Recall Bulletin

F/CMVSS NONCOMPLIANCE RECALL

SUBJECT: Windshield Washer Hose May Separate

MODELS: 2012 Chevrolet Sonic

2896898

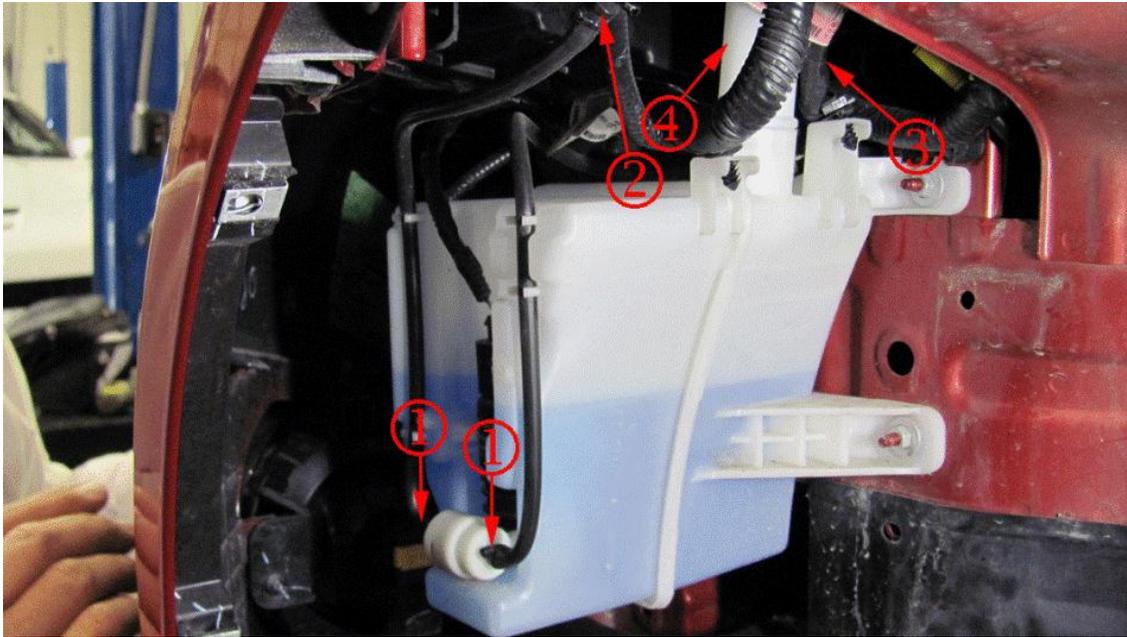
4. **“A” Sedan Vehicles:** Inspect the windshield washer bottle at the pump to determine if a band tie (1) is installed on the front hose of the pump. If a band tie (1) is not installed, install one as shown in the “A” portion of the illustration.

“B” Hatchback Vehicles: Inspect the windshield washer bottle at the pump to determine if two band ties (1) are installed on the front and rear hoses of the pump. If band ties (1) are not installed, install two band ties (1) as shown in the “B” portion of the illustration.

2896902

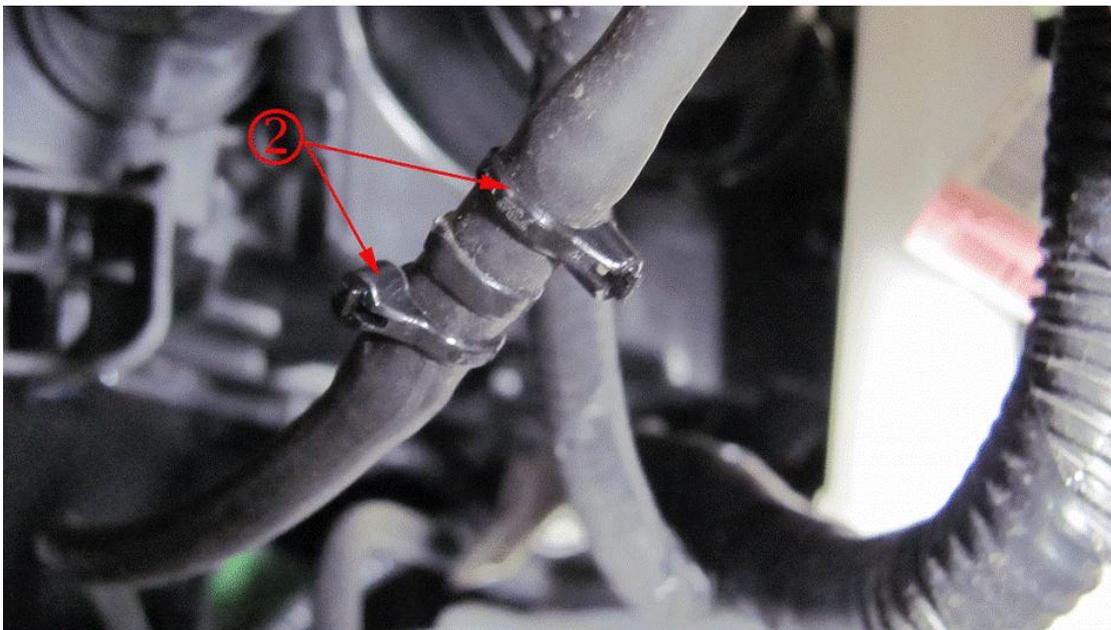
5. Install band ties at the following locations of the windshield washer hoses:
 - **Sedan Vehicles:** Install 1 band tie at the pump location (1), if required, and 2 band ties at the front hose connection (2).
 - **Hatchback Vehicles:** Install 2 band ties at the pump location (1), if required, 2 band ties at the front hose connection (2) and 2 band ties at the rear hose connection (3). The windshield washer bottle neck (4) will have to be removed to gain access to the rear hose connection. Re-install the windshield washer bottle neck after installing the band ties at the rear hose connection.
6. Install the front wheelhouse liner inner front extension. Refer to *Front Wheelhouse Liner Inner Front Extension Replacement* in SI.
7. Install the front driver side (left) tire and wheel assembly. Refer to *Tire and Wheel Removal and Installation* in SI.
8. Lower the vehicle.

2897001

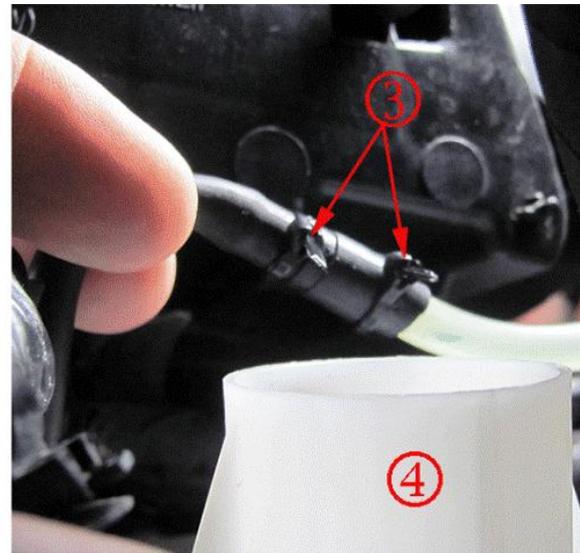
Install 2 band ties at the front hose connection (2).

2897003

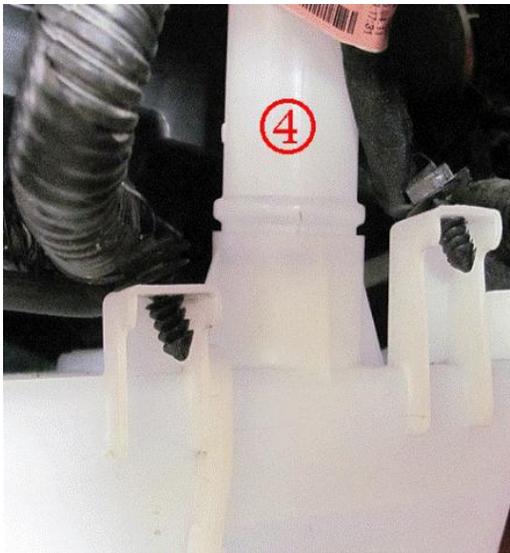
To gain access to the rear hose connection, remove the windshield washer bottle neck. Turn the neck (4) counterclockwise to remove the neck (4). Install 2 band ties at the rear hose connection (3).
